# Access Compliance Report

## Public Rights-of-Way

### (Curb Ramps)

Intersection ID: 14193	Main Street: E_5TH_ST	Cross Street: N_CASWELL_RD	Location: SE
ADA ID: E5F4D49FE419	Ramp Type: Perp	Initial Pass/Fail: Fail	Overall Compliance: No
Severity Score: 12.5			
Codes/Mitigation Info/Possible Solution		Field Measurements/Component Compliance

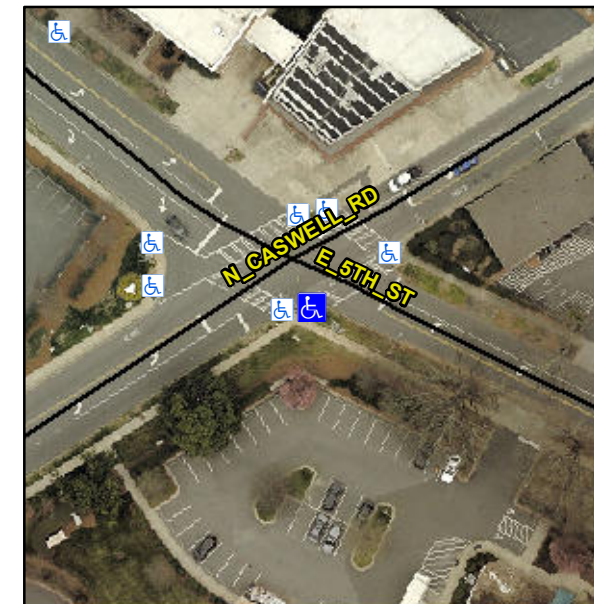
**Not Found, R304.2.2**

Compliance	Description	Data	Compliance	Description	Data
N/A	Ramp Length (in)	36.0	No	Ramp Slope (%)	11.9
Yes	Ramp Width (in)	48.0	Yes	Ramp XSlope (%)	1.1
N/A	Flare Type LT	N/A	N/A	Flare Type RT	N/A
N/A	Flare Slope LT (%)	N/A	N/A	Flare Slope RT (%)	N/A
N/A	Flare Traversable LT?	N/A	N/A	Flare Traversable RT?	N/A
N/A	Landing Length (in)	N/A	N/A	DWS Provided?	N/A
N/A	Landing Width (in)	N/A	N/A	DWS Contrast?	N/A
N/A	Landing Slope (%)	N/A	N/A	DWS Length (in)	N/A
N/A	Landing X Slope (%)	N/A	N/A	DWS Full Width?	N/A
N/A	Landing Curb? (Y/N)	N/A	N/A	DWS Offset (in)	N/A
N/A	Shared Landing?	N/A			
N/A	Gutter Ponding?	N/A	N/A	Gutter Slope (%)	N/A
N/A	Gutter Lip Ht (in)	N/A	N/A	Gutter X Slope (%)	N/A
N/A	Painted X Walk1?	Yes	N/A	Painted X Walk2?	N/A
	X Walk 1 Direction	To E		X Walk 2 Direction	N/A
N/A	X Walk 1 Width (in)	115.0	N/A	X Walk 2 Width (in)	N/A
	X Walk 1 Slope (%)	2.8		X Walk 2 Slope (%)	N/A
	X Walk 1 X Slope (%)	0.5		X Walk 2 X Slope (%)	N/A

**Remove & Replace Entire Ramp.**
